Publix at Courtyard Shoppes

STAFF REPORT

Petition Number: 2022-0007 ARB

Request: The agent, James Crowley, on behalf of the applicant, Publix Super Markets, Inc., is requesting Architectural Review Board (ARB) approval of the exterior elevations and signage with technical deviations for the Publix at Courtyard Shoppes.

Proposed Elevations (Front):

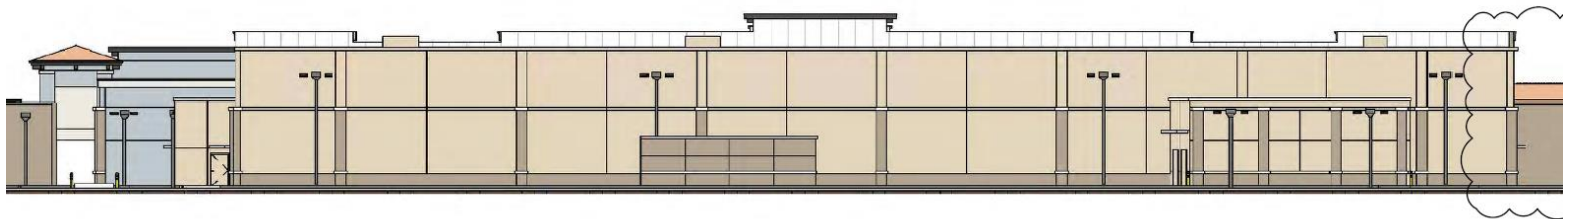
Per Section 6.4.4.A.3 of the LDR, windows shall be incorporate into the design on all facades facing a roadway and shall occupy, at a minimum, 40% of the elevation. Per Exhibit D – Window Opening Calculation, only 13.14% of the primary façade of the newly renovated portion of the center incorporated windows. The remainder of the plaza provides, on average, 44% of the façade with window openings. Staff has required faux windows on other developments including CVS at Town Square and Isla Verde, just to name a few. Staff recommends the incorporation of more windows openings on the bottom floor of the new building to meet a minimum of 18% of window area, which is an additional 5% of the Publix façade.

The proposed elevations utilize bright, crisp colors as shown in Exhibit which is contrary to what is existing. All color are on the ARB approved color palette. Staff recommends approval of the proposed colors, however, recommends the removal of Urban Bronze (SW7048) for the columns and replace with one of the bricks shown. In addition, the tile underneath the existing store fronts are proposed to remain the same. Staff recommends the use of either brick material instead of the outdated tile.

1. Exterior elevations and materials shall be consistent with Exhibit C with the following modifications:
 - a. Incorporation of more window openings on the bottom floor of the new Publix building to meet a minimum of 18% of window area, which is an additional 5% of the Publix façade.

- b. Removal of Urban Bronze (SW7048) for the columns and replace with one of the brick materials provided.
 - c. The tile underneath the existing store fronts are proposed to remain the same. Staff recommends the use of either brick material instead of the outdated tile.

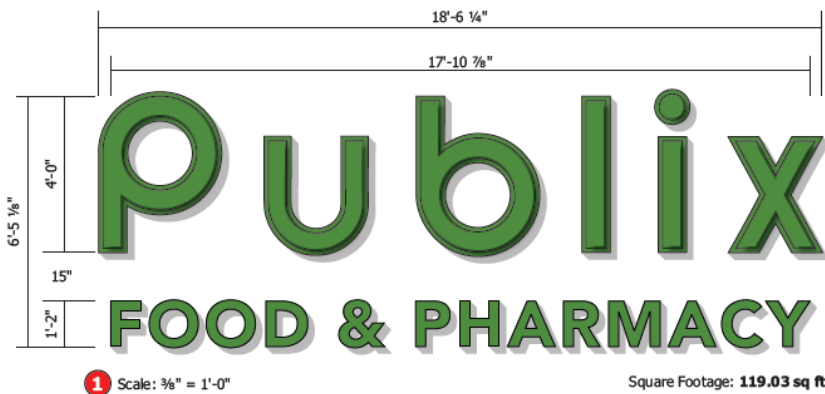
Per Section 6.4.1.A.6 of the LDR, all mechanical equipment located on a roof shall be screened with a parapet or enclosure that aesthetically blends the equipment with the building. The roof mounted equipment must not be seen at 10 feet above grade and 200 feet from the structure. Per Exhibit E – Proposed Roof Plan, all mechanical equipment will be fully screened from view either by location or by rooftop mechanical screenings. Prior to issuance of a Certificate of Occupancy, an inspection by Planning and Zoning Division will be required to ensure all mechanical equipment is adequately screened.

- 6. All roof top mechanical equipment shall be screened from view as shown in Exhibit E – Proposed Roof Plan. Prior to issuance of a Certificate of Occupancy, an inspection by Planning and Zoning Division is required to ensure all mechanical equipment is completely screened from view. Additional screening may be required if it is determined the equipment is not fully screened.

Publix Food and Pharmacy Sign:

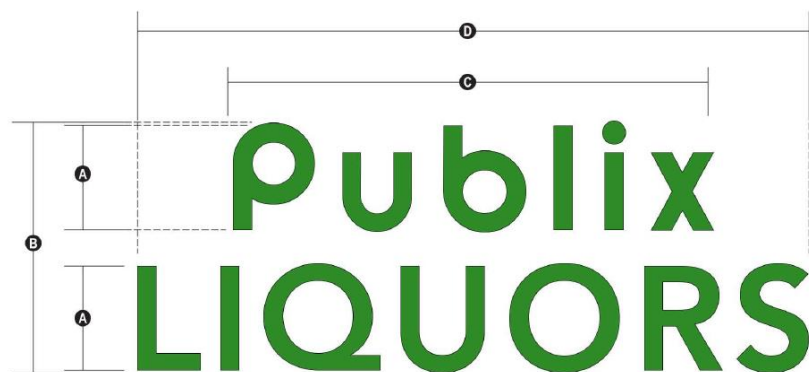
The applicant is requesting one (1) major tenant wall sign (Exhibit H – Major Tenant Wall Sign) on the primary façade that exceeds the maximum sign height by 12 inches. Per Section 7.9.7.A.1, a major tenant wall sign shall not exceed 66 inches in height, 80% of the length

of the façade, and 150 square feet. Proposed sign is 78 inches and meets the overall square footage requirements. A secondary wall sign is not requested and there is limited signage on the 284 foot Publix façade.

- 7. All site amenities shall match the colors that already exist within the center.
- 8. The Major Tenant Wall Sign (Publix Food & Pharmacy) shall be installed as shown in Exhibit H and meet the following requirements:

- a. Maximum Total Sign Area – 119.03 SF
 - b. Maximum Height – 6 feet 6 inches (Technical Deviation)
 - c. Maximum Length – 18 feet 7 inches
 - d. Maximum Lines of Copy – 2
